Central Sydney Industrial Estate and Downer Sustainable Road Resource Centre Modification 2

Lot Drainage and Subdivision
State Significant Development Modification Assessment
(SSD-10459-Mod-2)

Published by the NSW Department of Planning and Environment

Figure 5 | SSD-10459-Mod-2 – Proposed Stormwater Outlet (shown outlined in red)

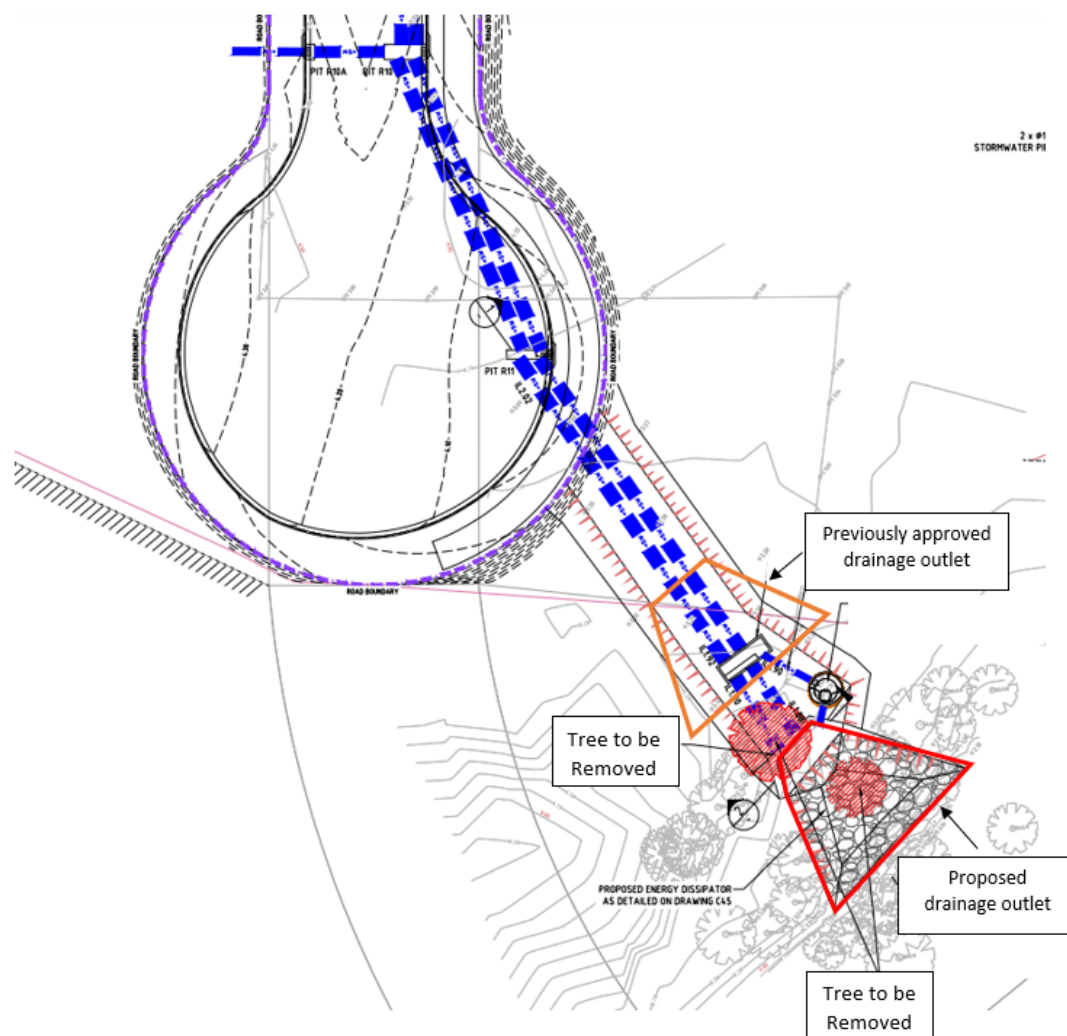
Due to the flat topography of the Site, the modification application is seeking to extend the dual 1,350 mm and 750 mm pipes a further 5 m to the south to ensure the drainage pipe run achieves a continuous fall from Devon Street to Duck River. The approved and proposed drainage outlet locations are shown in **Figure 5**. The proposed stormwater outlet location delivers a discharge point at a lower height but will require the removal of two semi-mature *Casuarina glauca* trees.

The proposed modifications to the stormwater infrastructure retains the approved outlet design, including rip rap to reduce the velocity of stormwater, as well as a spreading design to distribute water across a wide surface area, to mimic the existing natural state of drainage at the site.

Council did not object to the modification, however, did raise concerns around the removal of two mature *Casuarina glauca* trees as a result of the proposed works.

The Department liaised with the Department's Environment and Heritage Group (EHG) who confirmed there was insufficient information to determine the impacts to biodiversity values caused by the removal of the trees. As such, the Department sought further information from the Applicant in relation to this matter.

- Furthermore, the Applicant has proposed management measures including the establishment of an exclusion zone during construction and planting six new *Casuarina glauca* trees to appropriately manage any potential impacts.

- The Department has considered the findings of the ecological assessment and is satisfied the modification will not materially change the impact on biodiversity values. Additionally, the Applicant's proposed exclusion zone would minimise potential impacts during construction and the planting of new *Casuarina glauca* trees along with ongoing vegetation management would further enhance biodiversity values.

- Accordingly, the Department has recommended the Applicant's mitigation and management measures in Appendix 2 of the consent be updated to include additional measures.

- The Department notes the stormwater infrastructure is not changing with the exception of a small extension to the length of the pipe to allow for a discharge point at a lower height and is satisfied there will be negligible impact.

Figure 6 | SSD-10459-Mod-2 – Proposed Stage 1B and Stage 1C

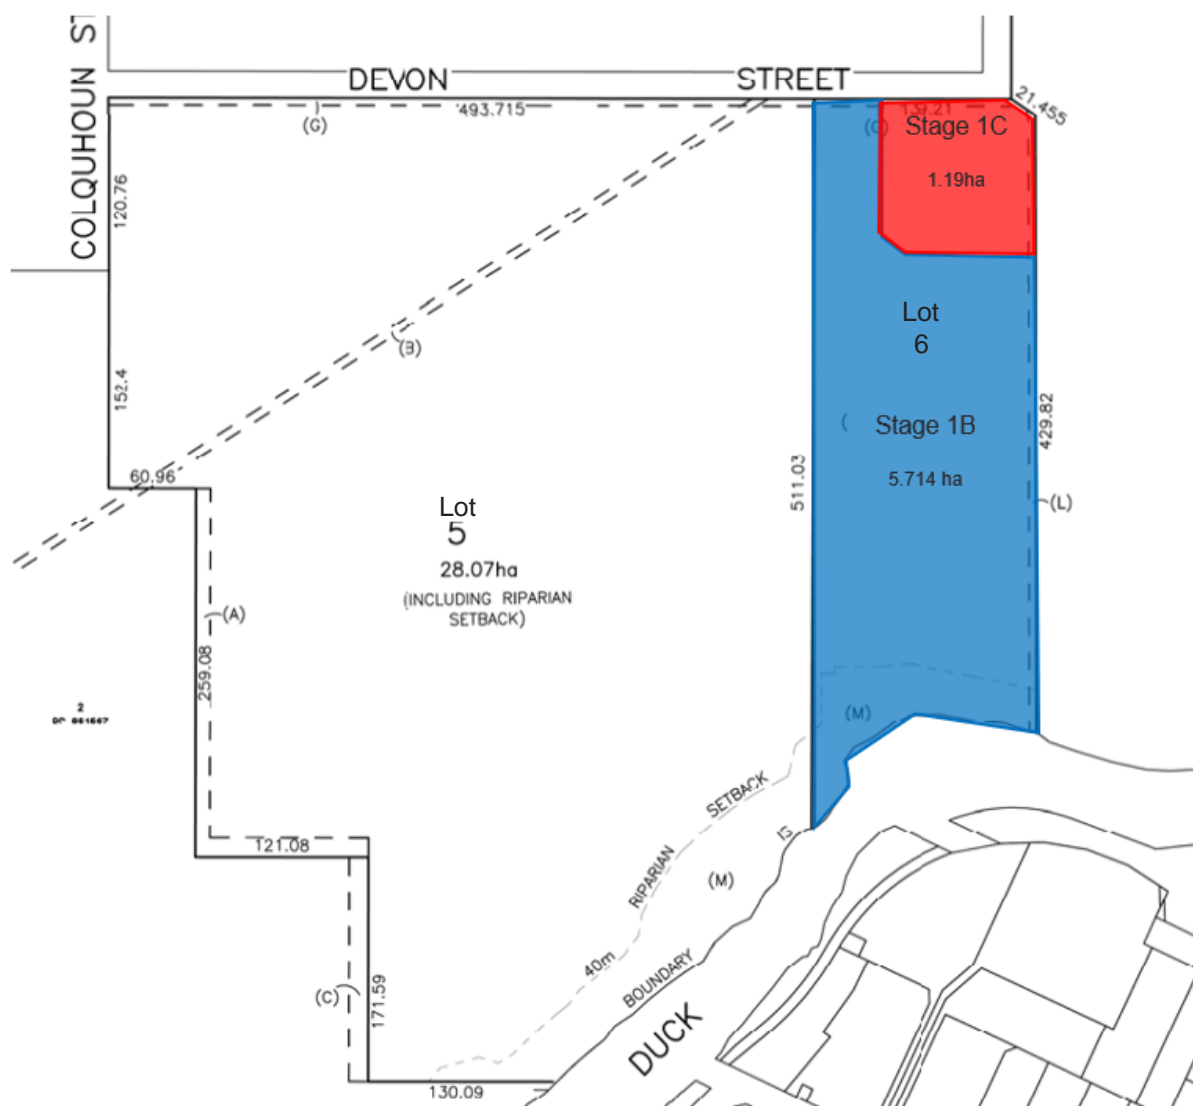
- The modification application is also seeking approval to further subdivide Lot 6 to create two smaller lots within the approved subdivision, described in **Figure 6** as Stage 1B and Stage 1C. The Applicant states this will enable the disposal of unused land. Land described as Lot 6 DP 1271928 will be the site subject to subdivision. This will result in Lot 6 being separated into two lots with 1C being 1.19 ha and 1B being 5.714 ha.

- The proposed subdivision has the potential to increase the working population or introduce a sensitive land use near a potentially hazardous facility as the proposed subdivision is located near the Viva Energy's Clyde Terminal which is classified as a major hazard facility under the *Work Health and Safety Act 2011*.

- The Department's Hazardous Industry Planning Advisory Paper no 10 (HIPAP 10), requires a development proposal that involves a significant intensification of population in the vicinity of a potentially hazardous facility to evaluate the change in societal risk, even if individual risk criteria are met.

- The Applicant provided an estimated population density for both day and night populations associated with the proposed development (four people per hectare during daytime, and up to three people per hectare during nighttime hours) which is well below the base case population density (29 people per

hectare daytime / 4 people per hectare nighttime), that allow societal risk to remain within the negligible area.

- Additionally, under the Camelia-Rosehill Place Strategy the site is zoned as IN3 Heavy Industry land meaning sensitive land use development is prohibited on the subdivided site.
- The Department has considered the potential impacts of the subdivision and is satisfied the modification will not increase the societal or individual risk.
- The Department's assessment concludes that the subdivision of the site will not result in the development of a sensitive use or increase the intensification of the site.
